MEB-CQ-201505 3.2.2 Responses

APR1400 DCD TIER 2

Figure 6.3.2-1 Safety Injection / Shutdown Cooling System Flow Diagram (4 of 4)

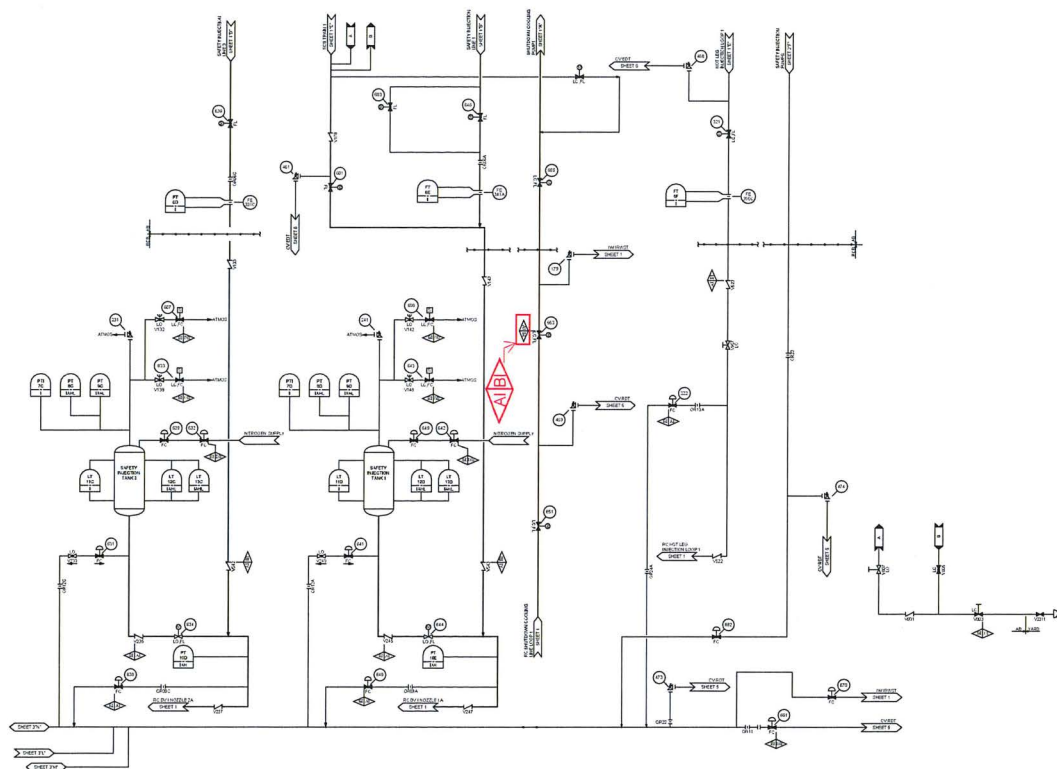
- b. DCD Tier 2, page 6.3-63 shows that SI-653 is Quality Group B, while page 3.2-74 shows it as Quality Group A.

SI-653 is Quality Group A. DCD Figure 6.3.2-1 will be updated to correct this error as shown in the attached MEB-CQ-201505 3.2.2 #9-b markup.
